Access Compliance Report

Public Rights-of-Way

(Curb Ramps)

Intersection ID: 5967	Main Street: N_TRYON_ST	Cross Street: MCCULLOUGH_DR	Location: NW
ADA ID: 99AFB155639A	Ramp Type: Perp	Initial Pass/Fail: Pass	Overall Compliance: No
Severity Score: 15.25			
Codes/Mitigation Info/Possible Solution		Field Measurements/Component Compliance

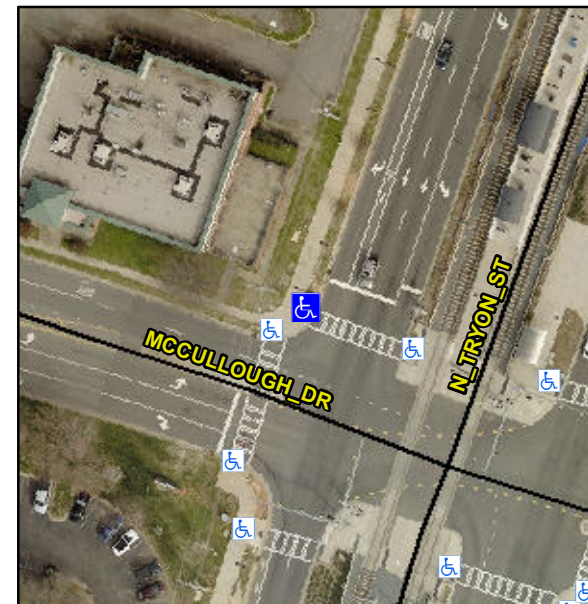
Not Found, R304.5.3, R304.2.2-Perp, R304.3.2-Para, R302.7.2

Compliance	Description	Data	Compliance	Description	Data
N/A	Ramp Length (in)	72.0	Yes	Ramp Slope (%)	5.4
Yes	Ramp Width (in)	48.0	No	Ramp XSlope (%)	2.6
N/A	Flare Type LT	Sloped	N/A	Flare Type RT	N/A
N/A	Flare Slope LT (%)	5.3	N/A	Flare Slope RT (%)	3.7
N/A	Flare Traversable LT?	Yes	N/A	Flare Traversable RT?	No
Yes	Landing Length (in)	118.0	Yes	DWS Provided?	Yes
Yes	Landing Width (in)	48.0	Yes	DWS Contrast?	Yes
No	Landing Slope (%)	2.2	Yes	DWS Length (in)	24.0
Yes	Landing X Slope (%)	0.4	Yes	DWS Full Width?	Yes
N/A	Landing Curb? (Y/N)	No	Yes	DWS Offset (in)	2.0
N/A	Shared Landing?	No			
Yes	Gutter Ponding?	No	Yes	Gutter Slope (%)	1.4
No	Gutter Lip Ht (in)	2.0	Yes	Gutter X Slope (%)	1.5
N/A	Painted X Walk1?	No	N/A	Painted X Walk2?	N/A
	X Walk 1 Direction	To SE		X Walk 2 Direction	N/A
N/A	X Walk 1 Width (in)	N/A	N/A	X Walk 2 Width (in)	N/A
	X Walk 1 Slope (%)	0.1		X Walk 2 Slope (%)	N/A
	X Walk 1 X Slope (%)	2.1		X Walk 2 X Slope (%)	N/A

N/A	Ramp inside XWalk1?	N/A	N/A	Ramp inside XWalk2?	N/A
	Road Slope (%)	N/A	N/A	Clear Space?	Yes
	Road X Slope (%)	N/A	N/A	Clear Space to XWalk (in)	N/A
Yes	Any Obstructions?	No	Yes	Storm Grate/Utility Hazard?	No
	Obstruction Type			Storm Grate/Utility Type	
		N/A			N/A
			Yes	Surface Condition? (G/P)	Good

Remove & Replace Entire Ramp.
